HOLDOVER
REVISED
HUNTER ADDITION TO
CEDAR POINT ROAD SUBDIVISION

APPLICATION NUMBER 20 DATE March 20, 2003

APPLICANT Hunter Addition to Cedar Point Road Subdivision

REQUEST Subdivision

LOCATOR MAP

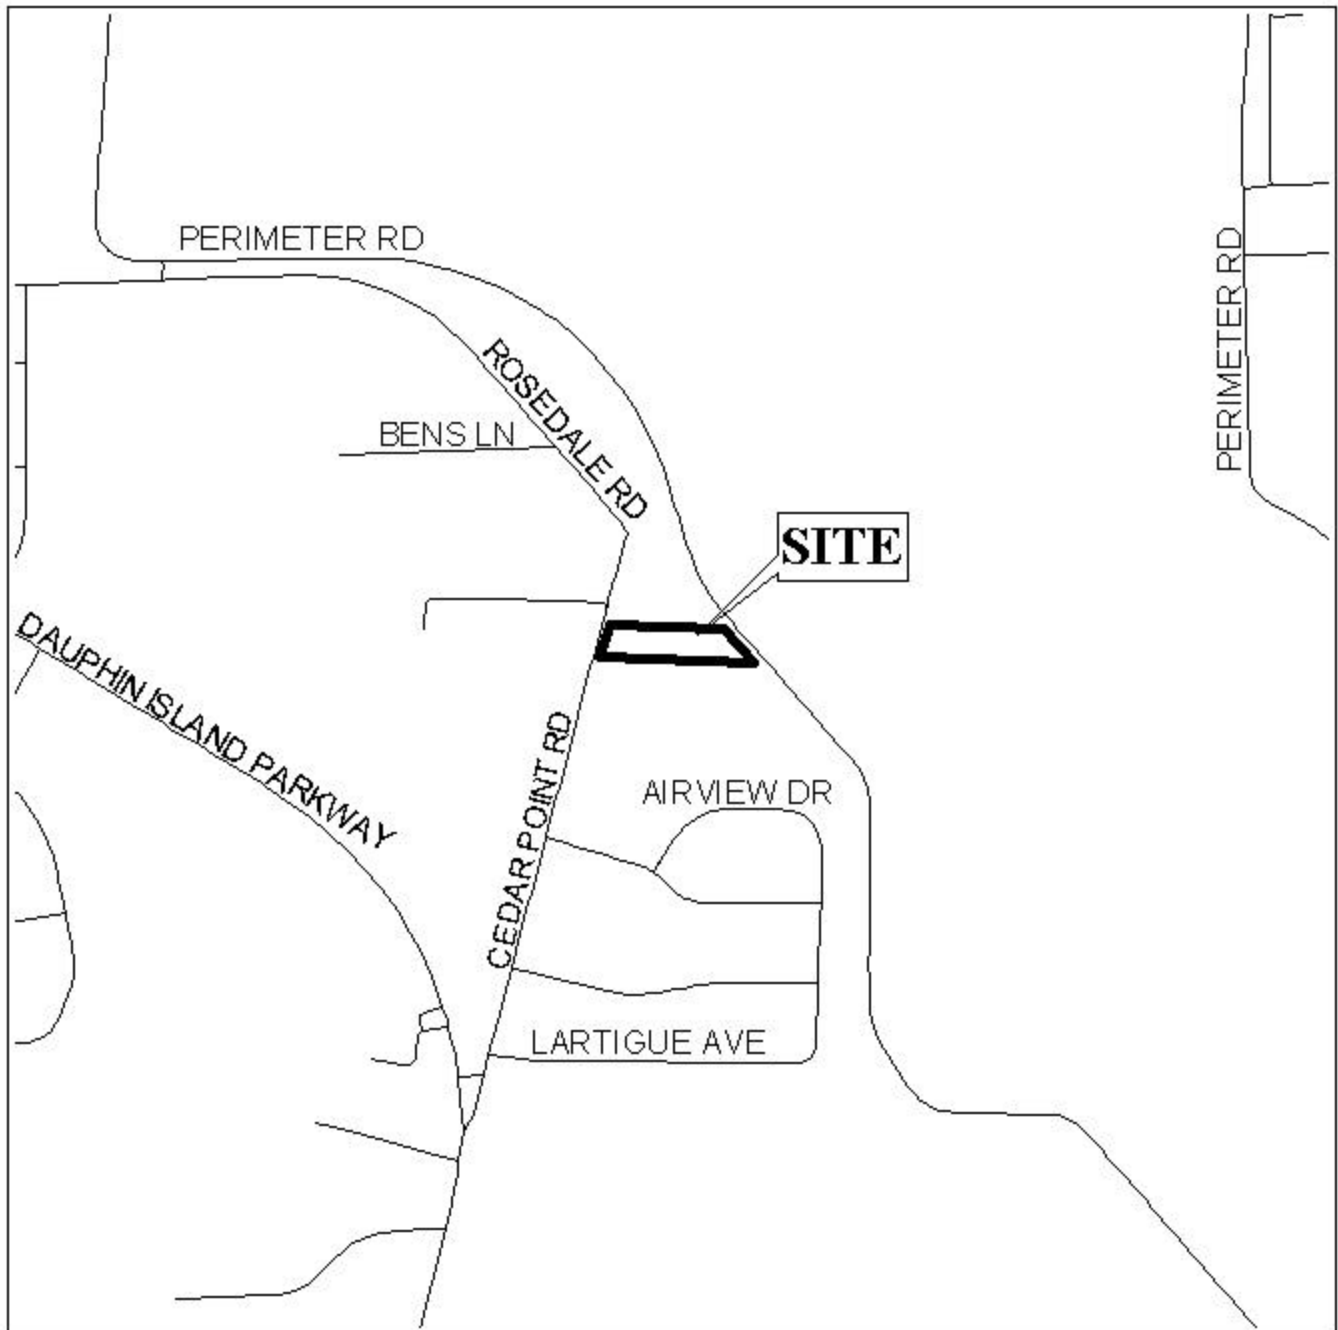
As illustrated on the Vicinity Map, the shaded area was deeded off via a metes and bounds description in 1997 and should be included in the subdivision.

Lots 1 and 2 exceed the maximum width to depth ratio as recommended by the Subdivision Regulations; therefore, a waiver of Section V.D.3. would be required.

With modifications and a waiver of Section V.D.3., the plat will meet the minimum requirements of the Subdivision Regulations and is recommended for Tentative Approval.
